MFN 253-95
Docket No. 52-004

Subject: SBWR - Non-Proprietary Version of RAI Responses Submitted May 31, 1994

Purdue RAI Set 4

FLOW PATH FOR DRYER (SEE QUESTION # 3)

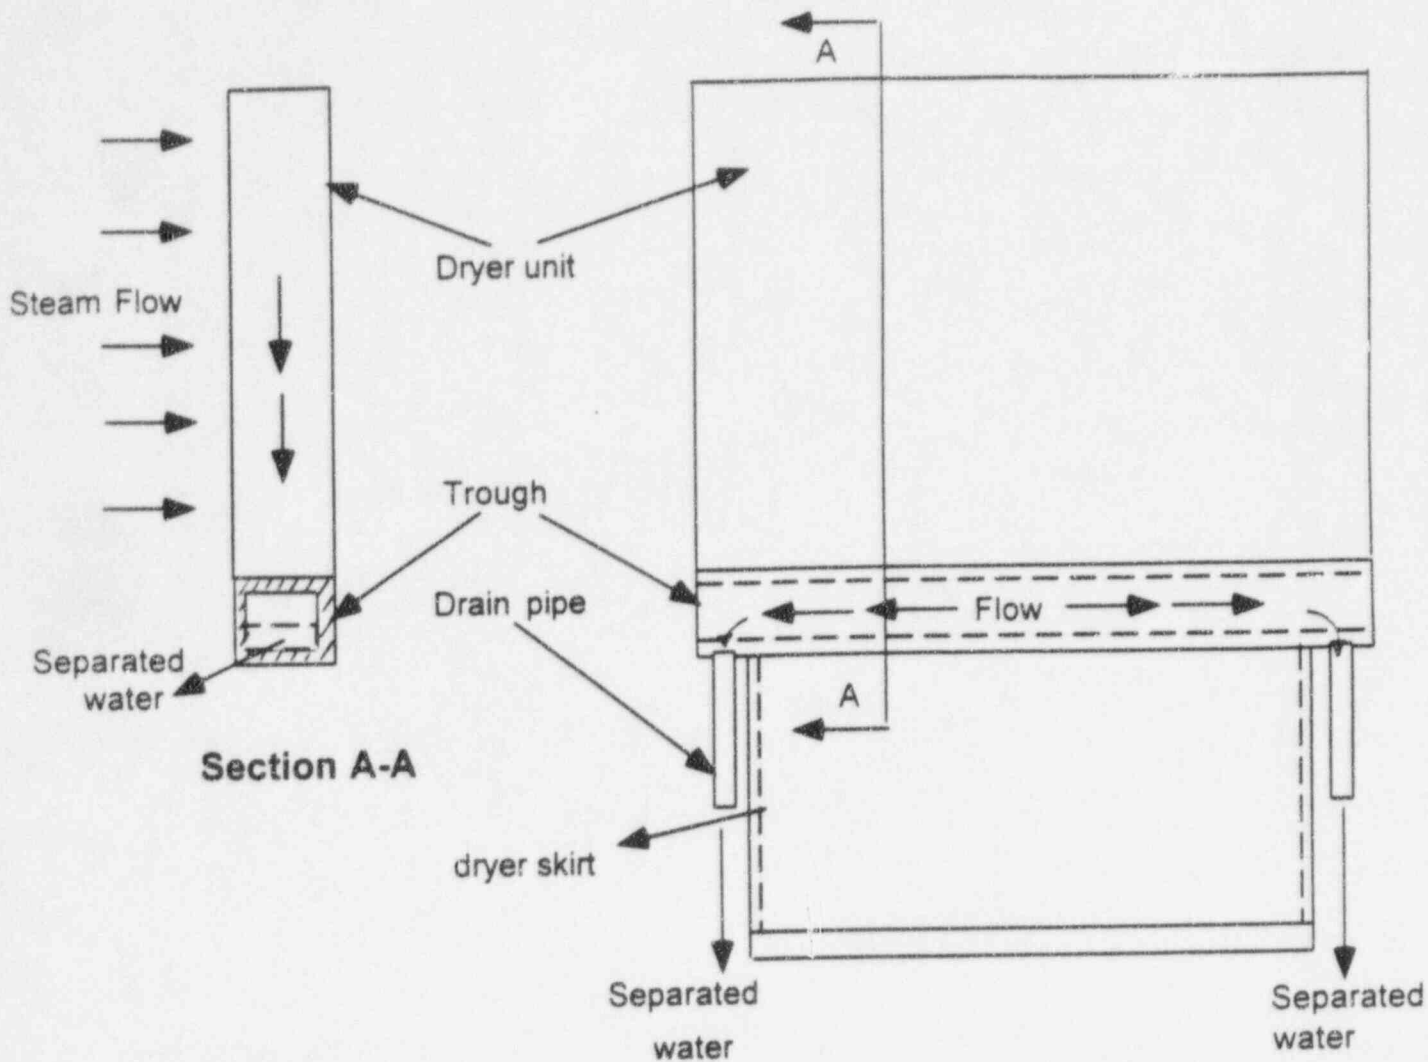
Provide the dimensions for the inside diameter and the outside diameter of the dryer skirt and the corresponding elevations of the dryer. Provide a clear picture of the flow paths for water collected in the dryer troughs to return to the downcomer annulus through the pool surrounding the steam separators. What are the flow area and clearance in the annulus between the dryer skirt and vessel inner wall (at the elevation of a main steam line)?

The dryer skirt inside and outside diameters and the corresponding dryer elevations are provided in References 1 and 2. The attached figure titled, "Flow Path for Dryer" shows the flow path for water collected in the dryer troughs, for return to the downcomer annulus through the pool surrounding the steam separators. The flow area and clearance in the annulus between the dryer skirt and vessel inner wall, at the elevation of the main steam line, can be determined by using Reference 2.

Flow Path: Steam from the separators pass through the dryer units where dry steam is separated, and flows upward. The separated water is collected in the troughs, flows outward to the drain pipes, and down to downcomer region.

Feedwater Line Break Area Calculation (Response No. 13)

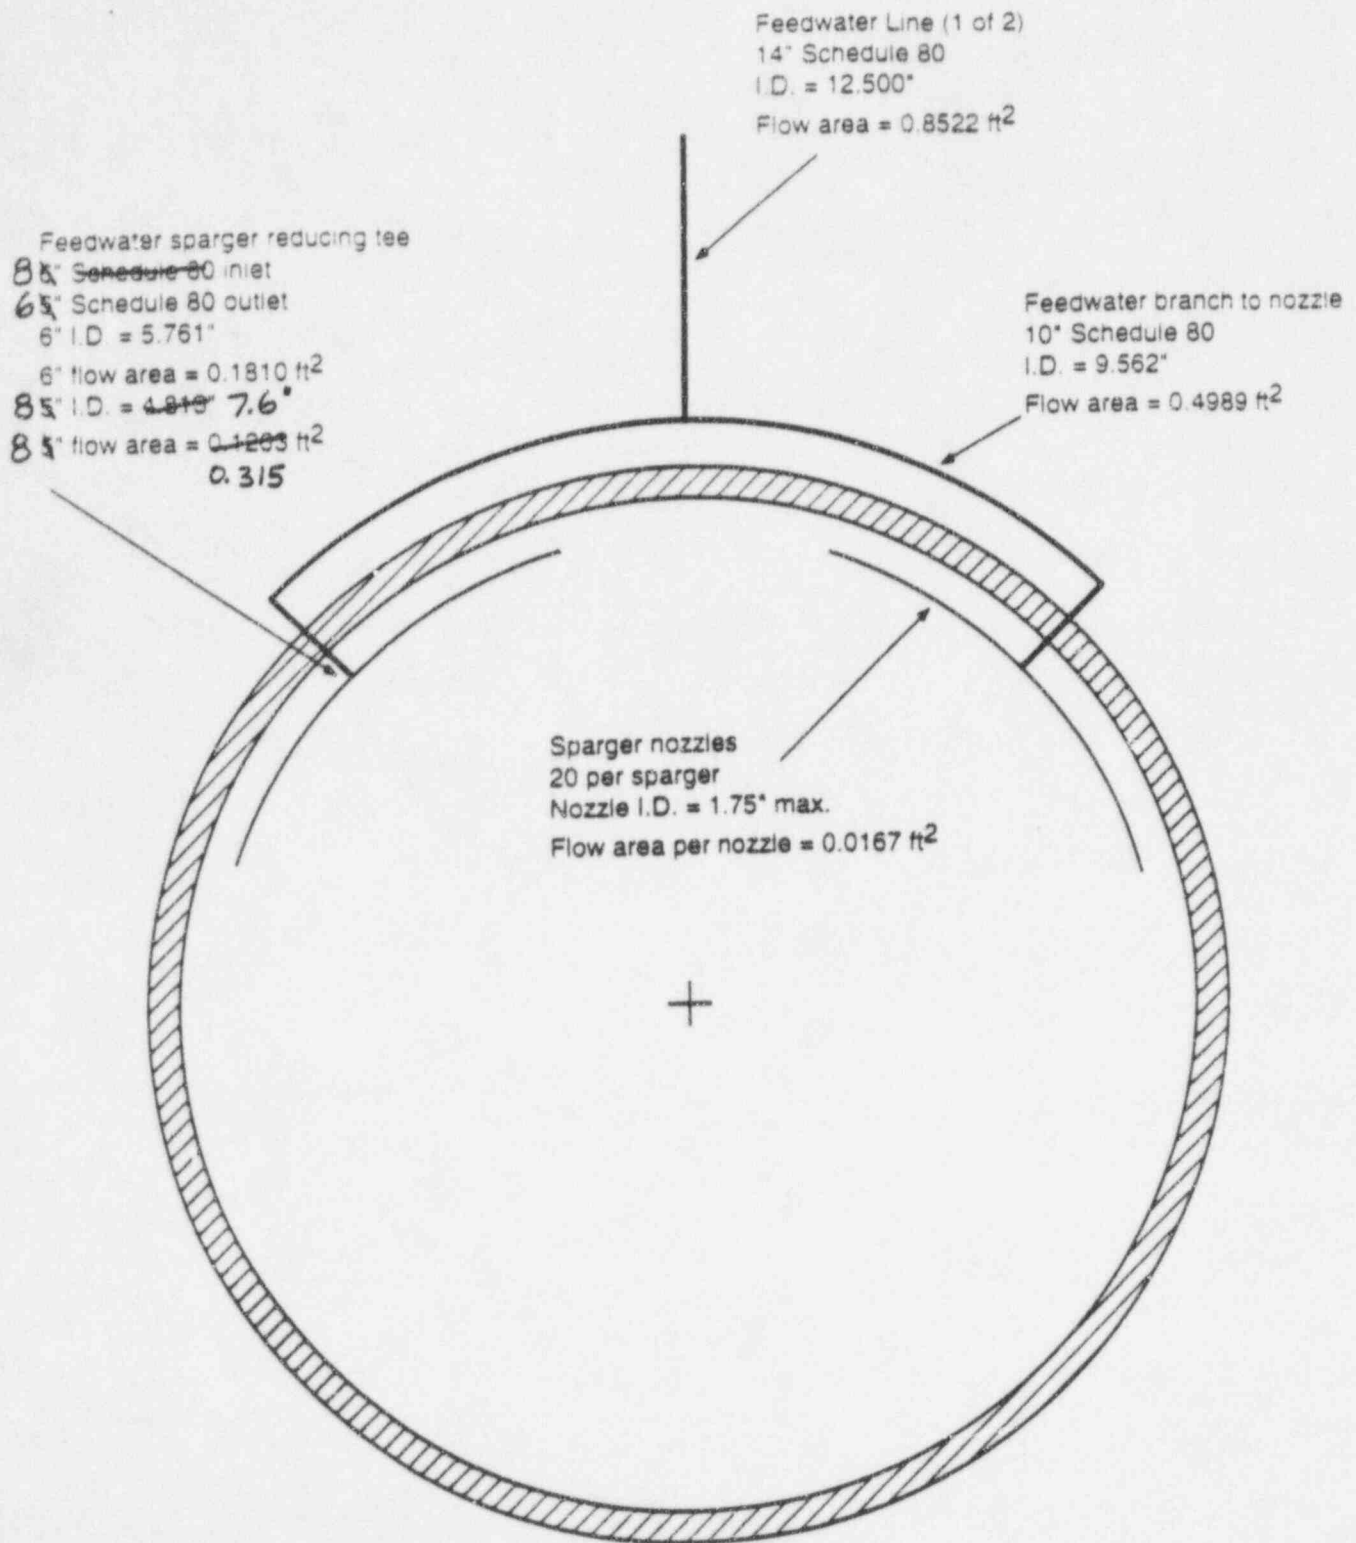
On page 6.3-20 of the SSAR, the feedwater line break size was listed as 8.9 in (inside diameter equivalent nozzle size). However, the pipe at the reactor pressure vessel penetration is a 10-inch Schedule 80 pipe with an inside diameter of 9.5 in. What is the correct break size for the feedwater line break?

The feedwater sparger details were previously provided in the response to question 1a of the first set of Purdue Questions. In order to reduce the fatigue stresses at the feedwater nozzle thermal sleeve, the design of the thermal sleeve and sparger has been revised. The figure that was included in the responses to the Set 1 questions has been revised and it is included with these Set 4 responses.

With the new design, the limiting feedwater line break area is 0.630 ft². For further details, refer to the attached figure titled, "Feedwater Line Break Area Calculation".

14" feedwater line	1 line		0.852 ft ²
10" feedwater branch to nozzle	2 lines		1.00 ft ²
8" Tee inlet	2 lines	0.630	0.382 ft ²
6" Tee outlet	4 lines	0.724	0.504 ft ²
Sparger nozzles	40 total		0.668 ft ²
Conclusion	-	Limiting break area =	0.630 0.382 ft ²
